Permit Number: 090716

This is to certify that Rgt Associates/Dirigo Masonryhas permission to Repair brick parapet, replace steel lintersAT 106 High St

Re: Parapet reconstruction – 108 High Street

RE: Katahdin restaurant building.

SECTION THRU EXISTING  
PERIMETER BEAM ASSEMBLY

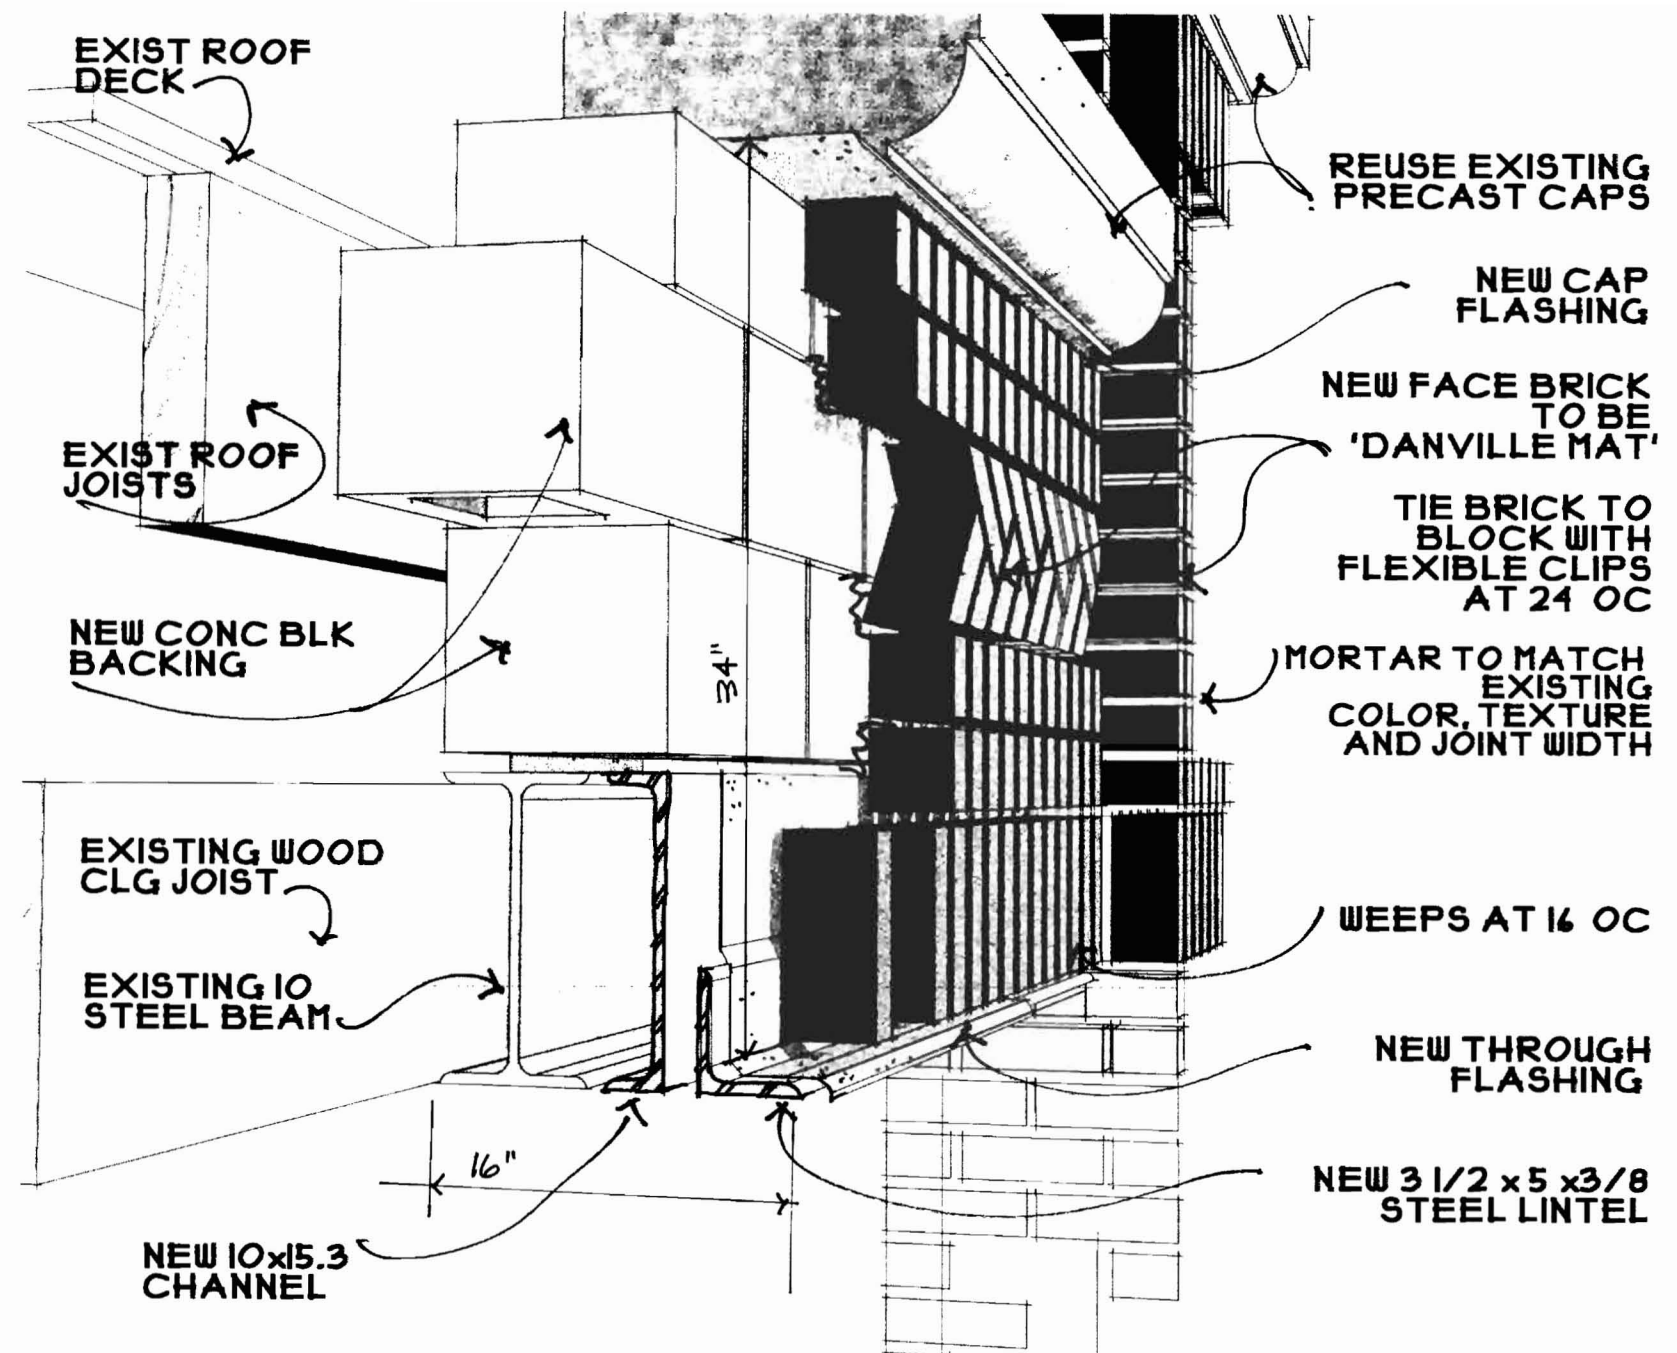
This building utilizes steel beams around the perimeter to support the upper portion of the brick walls and the brick and precast concrete parapet. The outer portions of this beam assembly, consisting of a channel section and an angle section, have deteriorated over the years due to exposure to the elements. The interior portion, a standard S10X25.4 beam, is still in good condition.

By measuring remaining portions of the channel section, I was able to determine the original section size. Structural analysis indicates the existing steel beam, together with a new channel section, is adequate to support the structural loads required by current building codes. Therefore, I recommend the deteriorated channel section be replaced by a new section of the same size, which is a C10X15.3.

The angle required to support the exterior course of brick can be of any size that works well for construction purposes.

Attached is a sketch showing a section through the beam assembly.
